TEEE 802.3da SPMD TF - 802.3da & Precision Time Protocol: 802.3da & Precision Time Protocol

Peter Jones - Cisco

802.3cg D3.1 comments #90 & #91

Figure 90–1—Relationship of the TimeSync Client, TSSI and gRS sublayer relative to MAC and MAC Client and associated interfaces

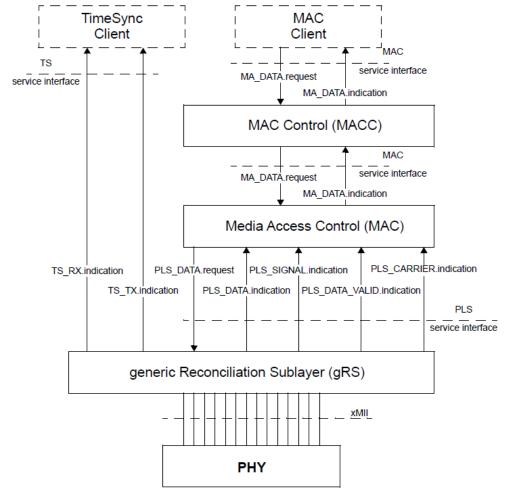
Comment #90 Suggested Remedy - *Updated*

Replace "The TSSI is defined for the full-duplex mode of operation only." with "The TSSI is defined for the full-duplex mode of operation, as well as clause 147 half-duplex point-to-point and multidrop."

Add the following paragraph to the end of 90.4.3.1.1 Semantics

The TSSI is defined for the full-duplex mode of operation only, as well as clause 147 half-duplex. It supports MAC operation at various data rates. The MII (Clause 22), GMII (Clause 35), XGMII (Clause 46), 25GMII (Clause 106), XLGMII (Clause 81), GMII (Clause 81), 200GMII (Clause 117), and 400GMII (Clause 117) specifications are all compatible with the gRS sublayer defined in 90.5.

When using the half-duplex mode of operation, multiple TS TX indications may be produced for a single MA DATA.request as a result of collisions on the media.

Figure 148-2-PLCA functions within the Reconciliation Sublaver (RS)

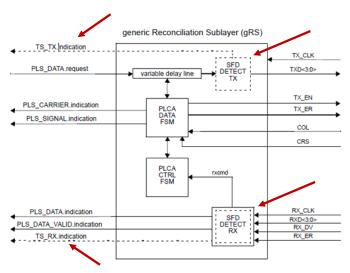
Modify "Figure 148-2--PLCA functions within the Reconciliation Sublayer (RS)" to add *TS_TX.indication, TS_RX.indication, SFD DETECT TX* and *SFD DETECT RX* as shown in 802.3cg 2019 D2.0 Figure 148-2.

Insert the following subclause before "148.4.2 Mapping of MII signals to PLS service primitives and PLCA functions"

148.4.2.1 Operation with TSSI

When TSSI is supported, transmit SFD detection occurs after the PLCA variable delay line, as shown in Figure 148-2.

Clause 90 defines TS_TX.indication (90.4.3.1) and TS_RX.indication (90.4.3.2). Clause 90 also defines TS_SFD_Detect_TX (90.5.1) and TS_SFD_Detect_RX(90.5.2), these are shown in Figure 148-2 as SFD DETECT TX and SFD DETECT RX respectively.
